NL100012

RE: DA 10/1049 158A & 164 CROUDACE ROAD ELEMORE VALE

I refer to the letter you provided to us from Newcastle City Council dated 21 December 2010 regarding DA 10/1049 for 158A and 164 Croudace Road, Elmore Vale. Below we have provided additional information and revised drawings for Council's assessment. The points addressed in this letter are a portion of Item 23 – Engineering Issues, and a part of Item 6 – Landscaping.

Manning's Channel Capacity Calculations

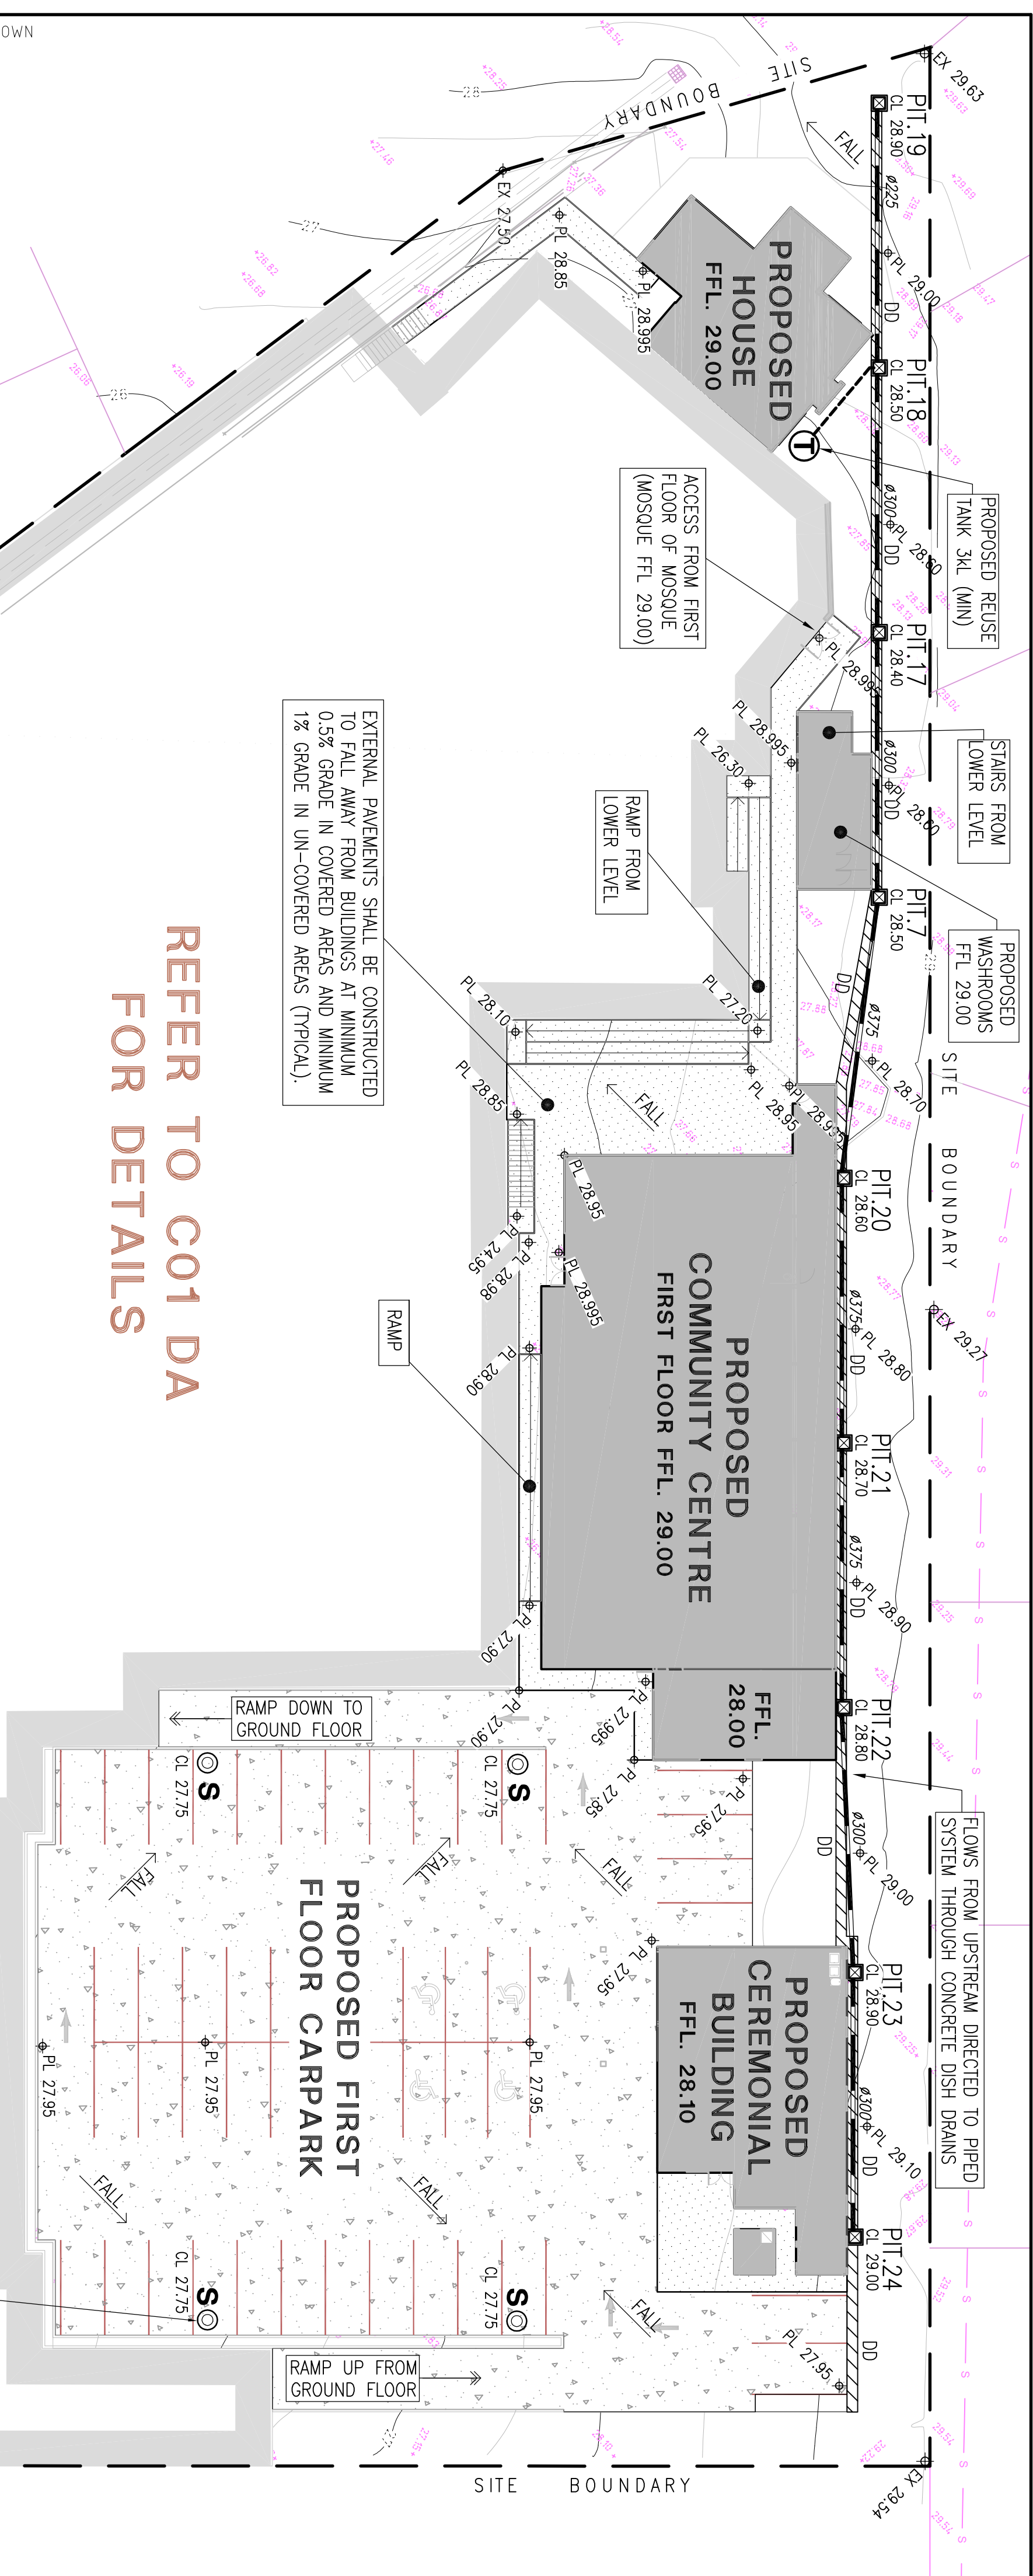
2. *Typical sections of the overland flow paths through the site and calculations to show that the 100yr flows through the site can be accommodated needs to be provided. In this regard critical sections are considered to be western boundary near the Mosque (noting the Mosque is in cut in this location), the rear boundary and the overland flow path beside the driveway.*

Assume $0.80\text{m}^3/\text{s}$ required for secondary flow path along easement.

$$\begin{aligned} A &= d/2(a+b) \\ &= 0.2/(2+3) \\ &= 0.50\text{m}^2 \end{aligned}$$

$$P = 2 \sqrt{0.5^2 + 0.2^2} = 3.08\text{m}$$

$$\begin{aligned} V &= 1/n (A/P)^{2/3} S^{1/2} \\ &= (1/0.035)(0.50/3.08)^{2/3} 0.07^{1/2} \\ &= 2.25 \text{ m/s} \end{aligned}$$

$$Q = V.A$$
$$= 1.13 \text{ m}^3/\text{s}$$

Therefore swale can adequately convey to 1 in 100yr ARI storm peak flow.

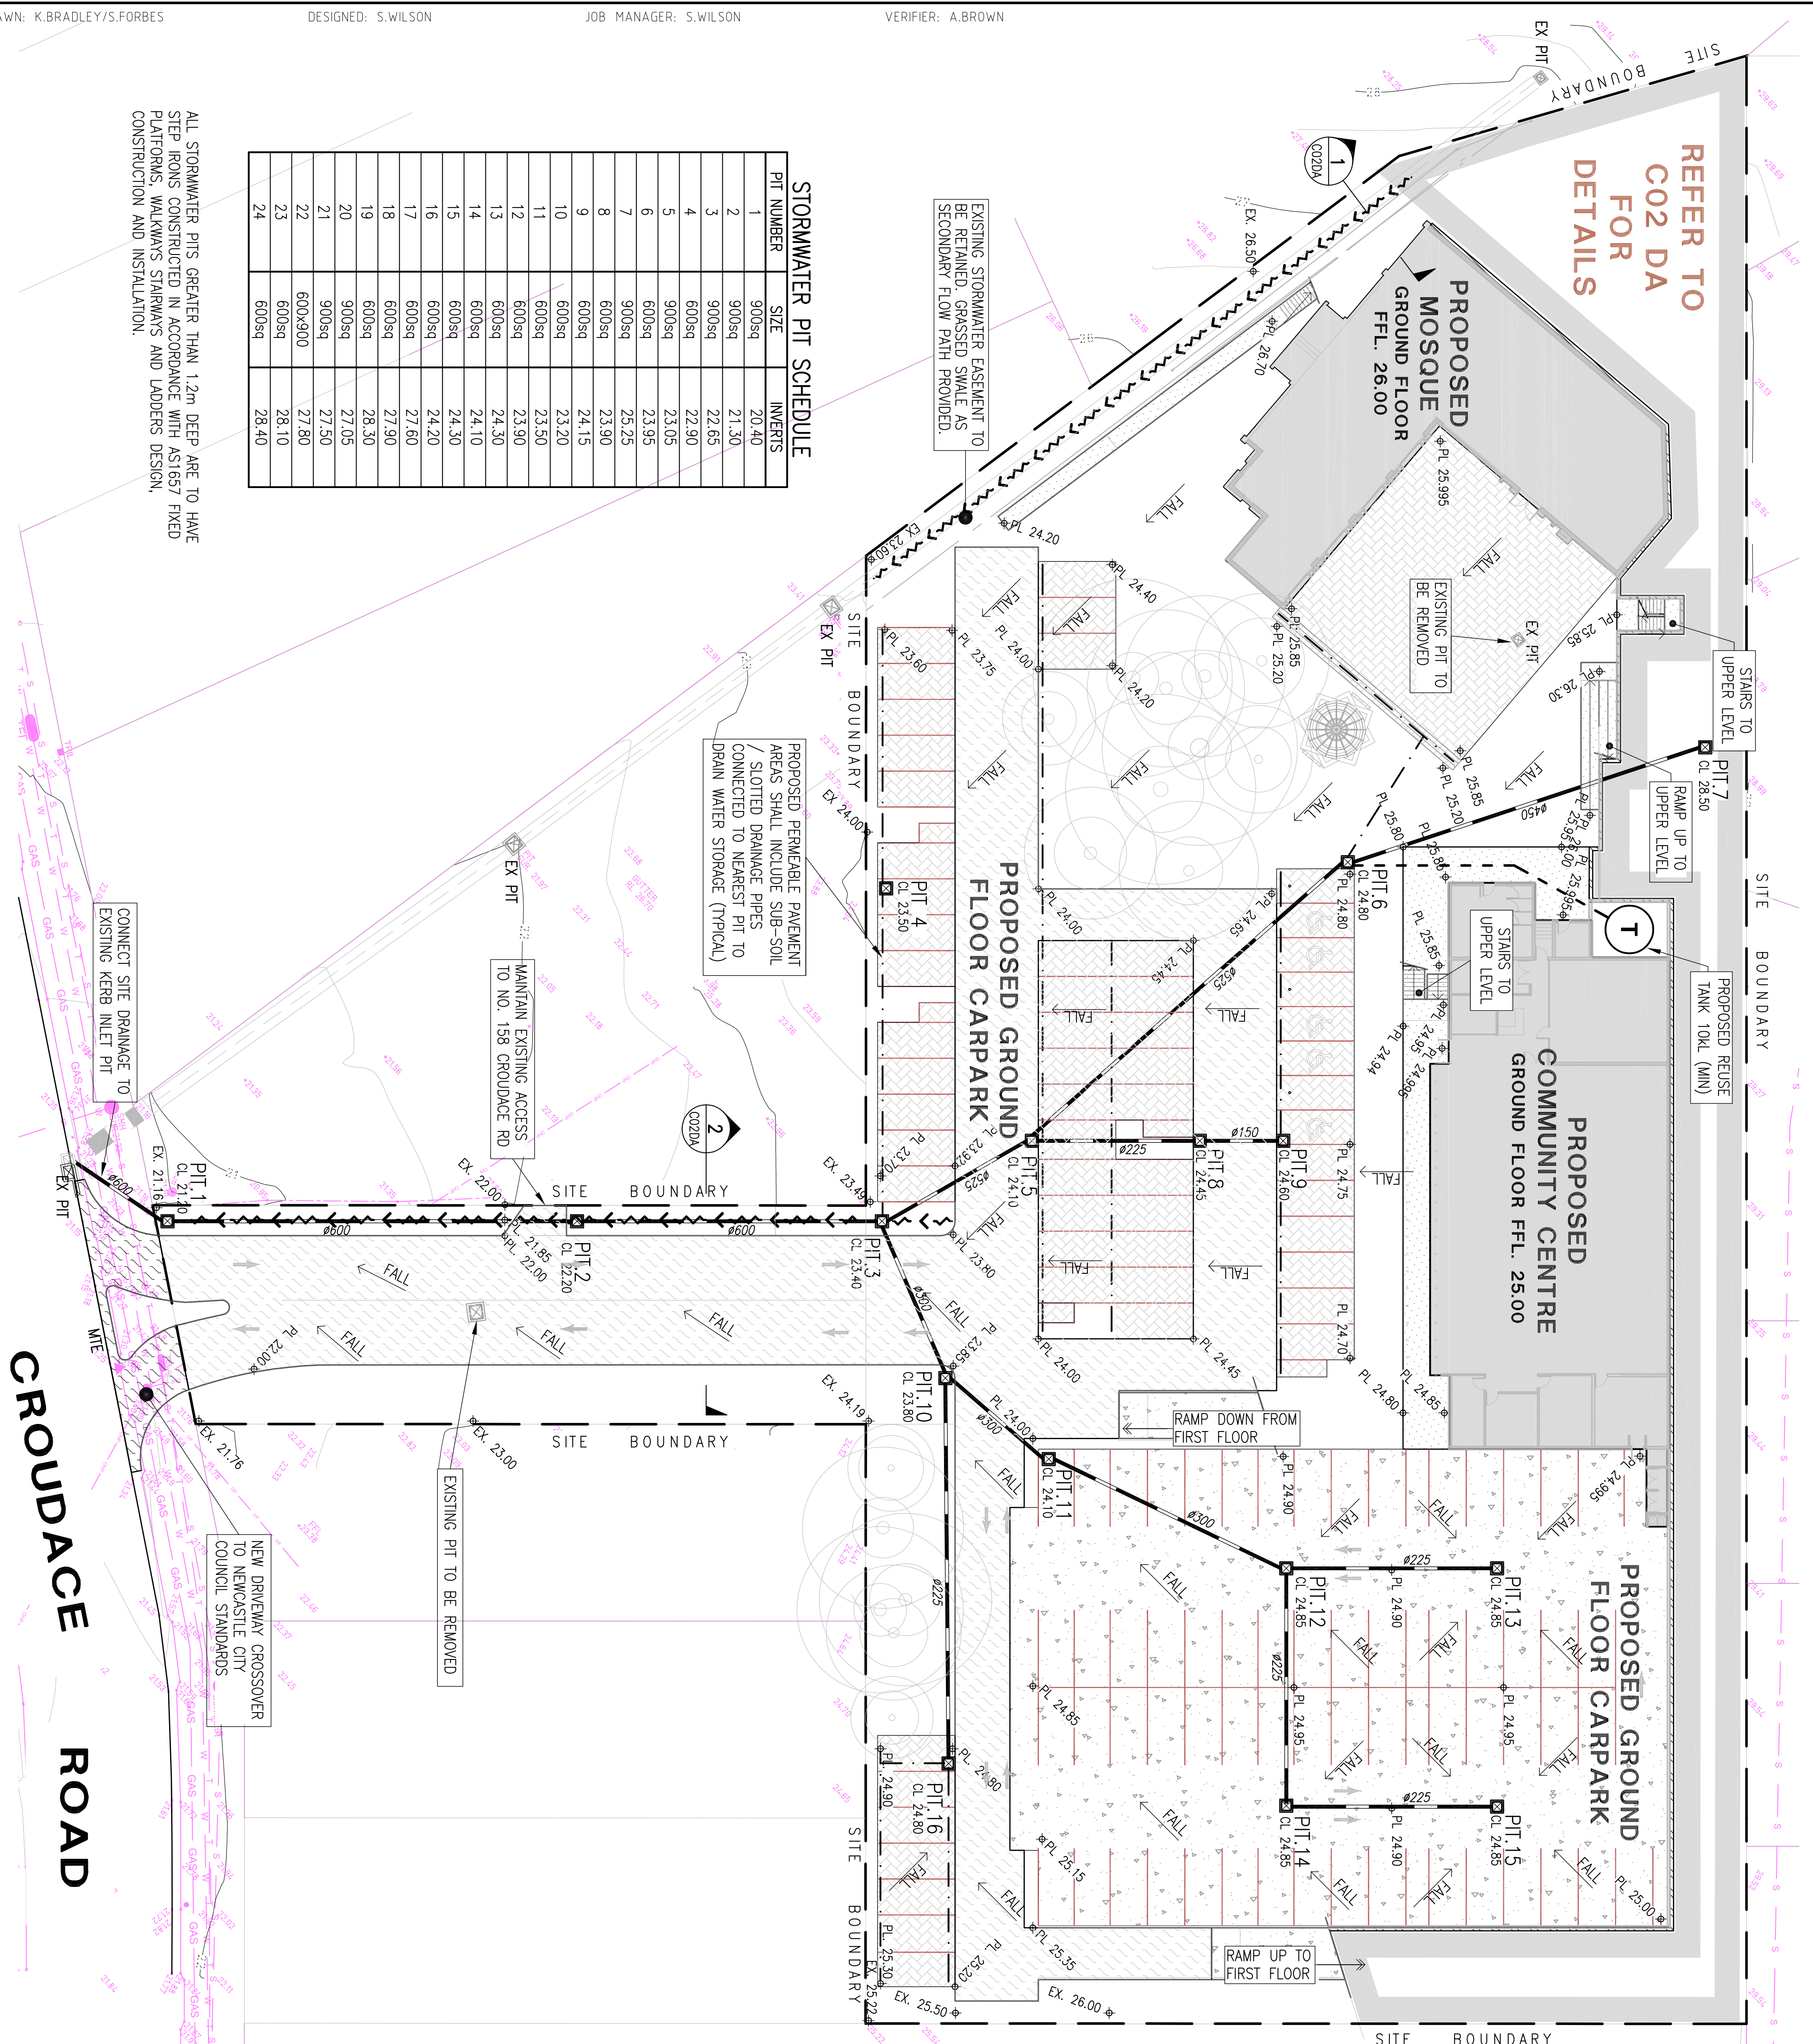
3. *The multi-storey car park drainage is currently shown ending at a pit in the south western corner of the car park. It should connect to the rest of the property drainage and this link needs to be shown.*

4. *A drainage pit is required at the top of the internal drainage line where the subsoil lines from the impermeable paving in the top car park meets the first solid drainage pipe.*

5. *The subsoil drainage line shown connecting the upstream and downstream pits in the central permeable paving car park is to be changed to a solid drainage pipe.*

6. *Pits are to be numbered and a Pit schedule provided showing pipe sizes and pit inverts.*

This has been amended in our latest drawings showing a solid drainage pipe between Pits 11 and 10. Please find these drawings attached.

This has been amended in our latest drawings as a new pit, Pit 9. Please find these drawings attached.

This has been amended in our latest drawings to show a solid drainage pipe.

This has been added in our latest drawings to show pit sizes and inverts, as well as pipe sizes. It is noted that these are preliminary sizes only, to be confirmed pending full design at Construction Certificate stage.
